Well Name: JAMES RANCH UNIT DI 7 SAWTOOTH	Well Location: T23S / R31E / SEC 6 / LOT 2 / 32.340327 / -103.815097	County or Parish/State: EDDY / NM
Well Number: 116H	Type of Well: CONVENTIONAL GAS WELL	Allottee or Tribe Name:
Lease Number: NMNM02953C	Unit or CA Name: JAMES RANCH UNIT	Unit or CA Number: NMNM70965X
US Well Number: 3001554882	Operator: XTO PERMIAN OPERATING LLC

Notice of Intent

Type of Submission: Notice of Intent	Type of Action: APD Change
Date Sundry Submitted: 04/24/2024	Time Sundry Submitted: 11:08
Date proposed operation will begin: 05/27/2024

WELL LOCATION AND ACREAGE DEDICATION PLAT

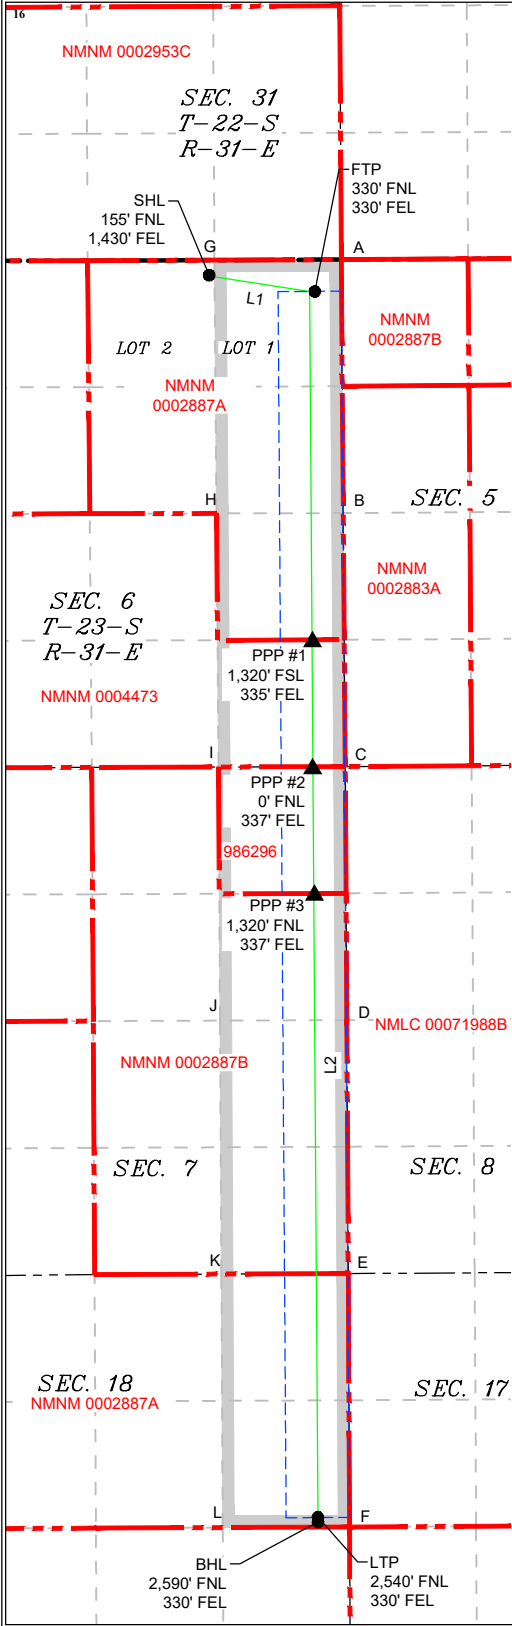
Procedure Description: XTO Permian Operating, LLC. respectfully requests approval to make changes to the approved APD as follows: SHL, FTP, LTP, BHL and proposed total depths (MD & TVD). FROM: TO: SHL: 155' FNL & 2050' FEL of Section 6-T23S-R31E 155' FNL & 1430' FEL of Section 6-T23S-R31E FTP: 700' FSL & 1430' FEL of Section 31-T22S-R31E 330' FNL & 330' FEL of Section 6-T23S-R31E PPP 1-2: 2638' FNL & 1433' FEL of Section 6-T23S-R31E 1320' FSL & 335' FEL of Section 6-T23S-R31E PPP 1-3: 0' FSL & 1436' FEL of Section 6-T23S-R31E 0' FNL & 337' FEL of Section 7-T23S-R31E PPP 1-4: 1320' FNL & 337' FEL of Section 7-T23S-R31E LTP: 2540' FNL & 1430' FEL of Section 18-T23S-R31E 2540' FNL & 330' FEL of Section 18-T23S-R31E BHL: 2590' FNL & 1430' FEL of Section 18-T23S-R31E 2590' FNL & 330' FEL of Section 18-T23S-R31E The proposed TD will change from 25552' MD; 11323' TVD (Wolfcamp) to 23907' MD; 11267' TVD (Wolfcamp). The pool will remain as Los Medanos; Wolfcamp, South. Casing and cement will be adjusted according to the new depths. ATTACHMENTS: C-102 and Directional Plan

The proposed TD will change from 25552 MD; 11323 TVD (Wolfcamp) to 23907 MD; 11267 TVD (Wolfcamp). The pool will remain as Los Medanos; Wolfcamp, South. Casing and cement will be adjusted according to the new depths.

¹⁰ Surface Location									
UL or lot no. 2	Section 6	Township 23 S	Range 31 E	Lot Idn	Feet from the 155	North/South line NORTH	Feet from the 1,430	East/West line EAST	County EDDY

¹¹ Bottom Hole Location If Different From Surface									
UL or lot no. H	Section 18	Township 23 S	Range 31 E	Lot Idn	Feet from the 2,590	North/South line NORTH	Feet from the 330	East/West line EAST	County EDDY
¹² Dedicated Acres 399.98	¹³ Joint or Infill	¹⁴ Consolidation Code	¹⁵ Order No.
